CITY OF ST. PETERSBURG, FLORIDA  
PLANNING AND DEVELOPMENT SERVICES DEPARTMENT  
URBAN PLANNING AND HISTORIC PRESERVATION DIVISION

## STAFF REPORT

Community Planning and Preservation Commission  
Certificate of Appropriateness Request

Case No.:	19-90200029
Address:	Dr. MLK St S from 6 <sup>th</sup> Ave S to 7 <sup>th</sup> Ave S
Date of Construction:	n/a
Local Landmark:	Roser Park Local Historic District (HPC 87-01) – Replacement of Contributing Structure
Owner:	City of St. Petersburg
Request:	Request for a Certificate of Appropriateness for new construction

- Proposed Rendered view from Roser Park (Existing trees – preserved)

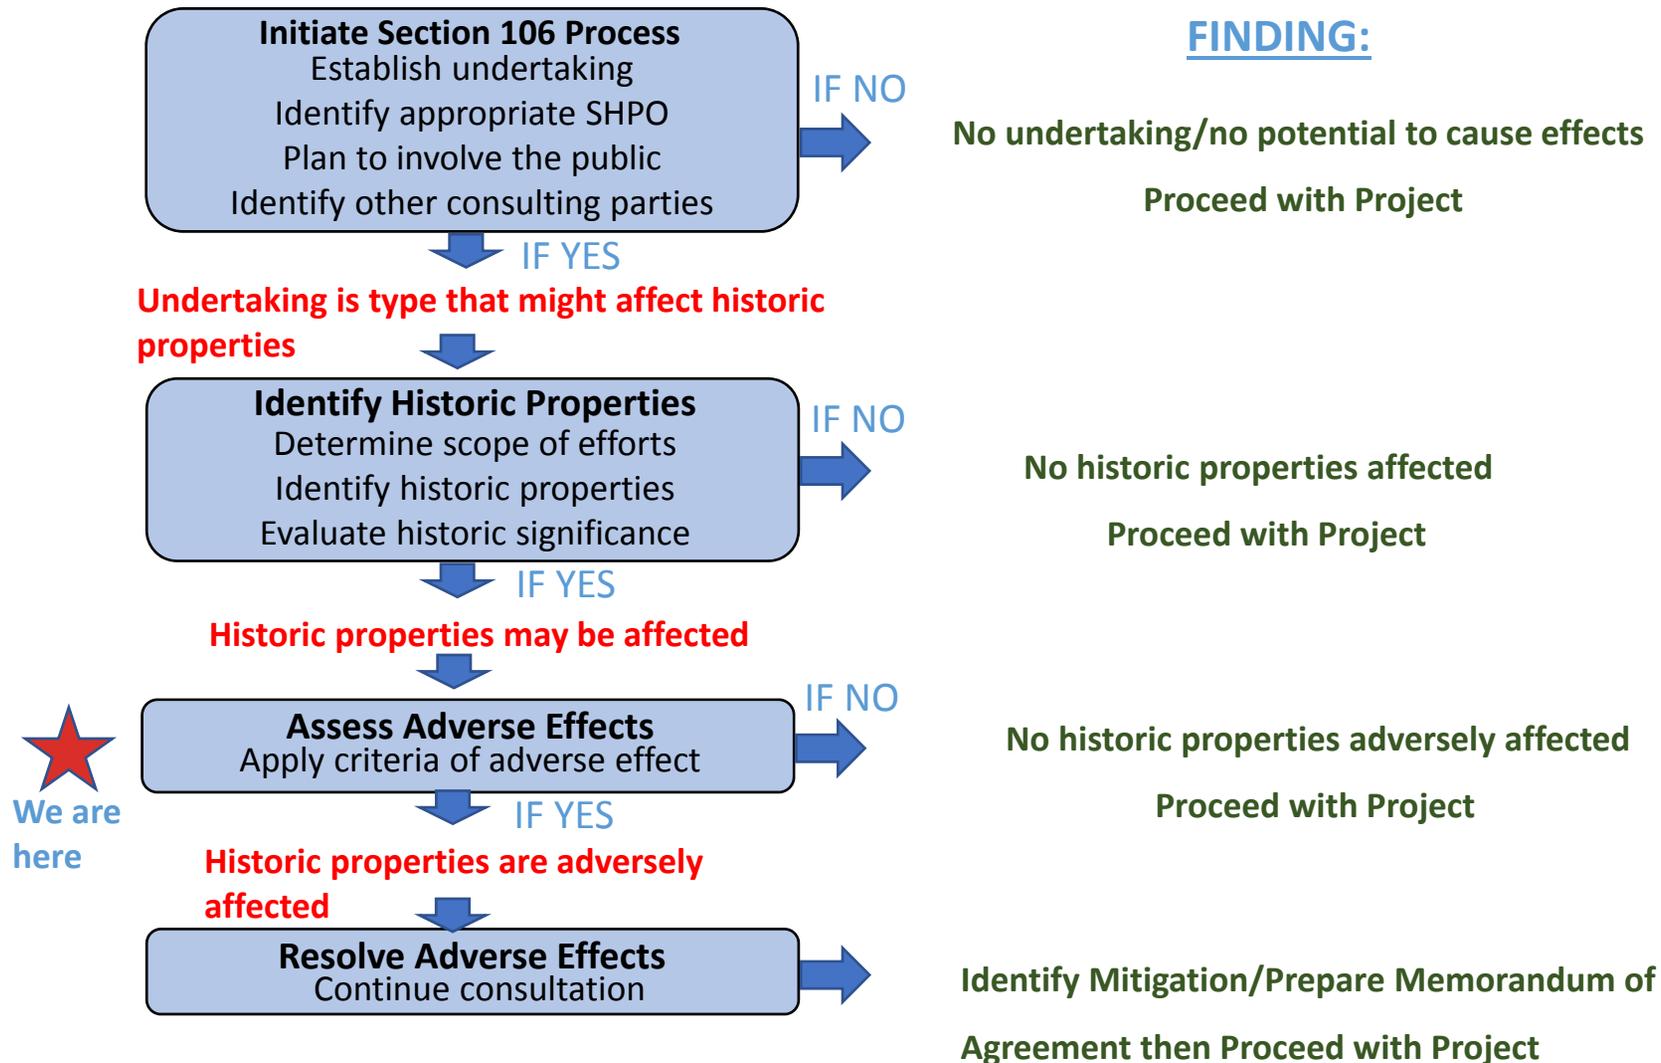
Q: Has there been any feedback on the substructure? The MSE walls don't seem to fit the character of the neighborhood

- Action: Craig noted a ballpark estimate could be provided.
- Residents noted that there was illegal activity occurring under the bridge and this design may help with these issues.
- It was noted there is no existing view from the Campbell Park side.
- It was noted that a façade may be used on the substructure.

A: The cost of converting the MSE walls to piles would be a substantial cost and the city would have to fund this.
